CITY OF NORWALK
Transportation Mobility & Parking
P: 203-854-7260
Norwalk City Hall
125 East Avenue, PO Box 5125
Norwalk, CT 06856-5125

Subject: TMP Traffic Impact & Assessment: iPark Expansion, 761 Main Avenue, Norwalk

Memorandum

Recommended Intersection Improvements

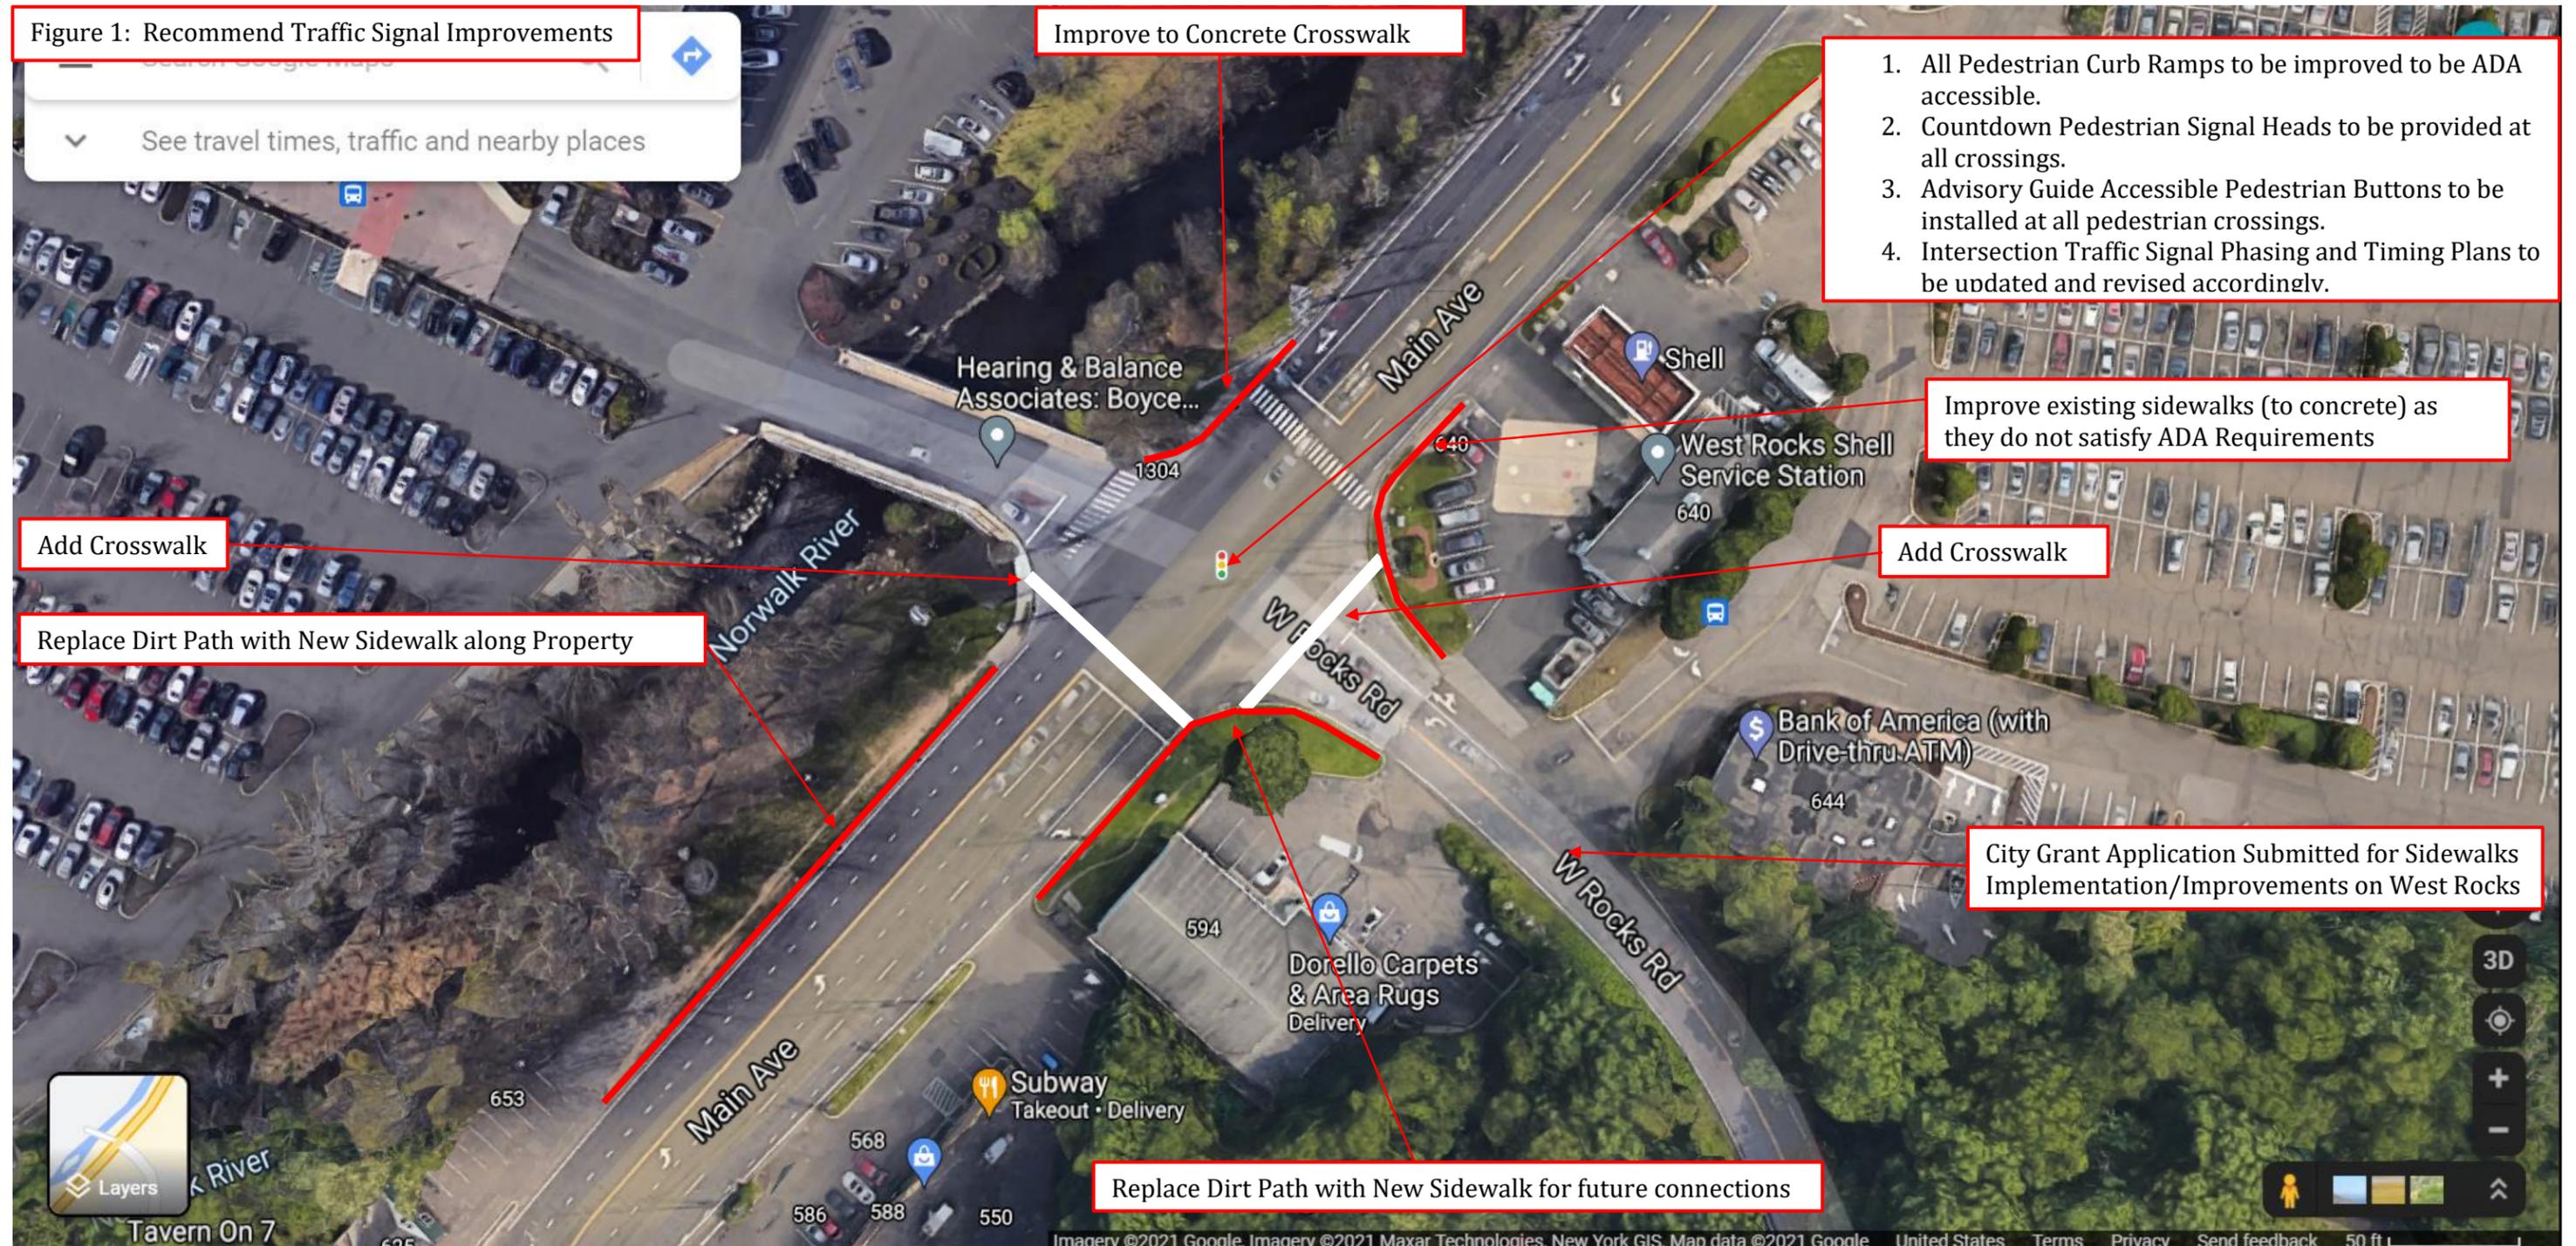
1. WSP recommends upgrading existing curb ramps at the intersection of Main Avenue and West Rocks Road/the Site Driveway to be ADA compliant. The count data indicates there are existing pedestrian volumes and the apartments and hotel will add further pedestrian trips to/from the Site. The following additional improvements (graphically illustrated in Figure 1) are necessary to safely accommodate pedestrians at the intersection of Main Avenue and West Rocks Road/the Site Driveway:

- a. Sidewalk improvements at all four corners of the intersection.
 - b. The addition of crosswalks on the southerly and easterly leg of the intersection.

- c. Pedestrian Curb Ramp improvements for ADA accessibility (all corners)
 - d. Implementation of Countdown Pedestrian Signal Heads (at all crossings)

- e. Implementation of Advisory Guide Accessible Pedestrian pushbuttons (at all crossings)
 - f. Revisions and Updates to the Traffic Signal Phasing and Timing Plans to reflect the aforementioned comments.
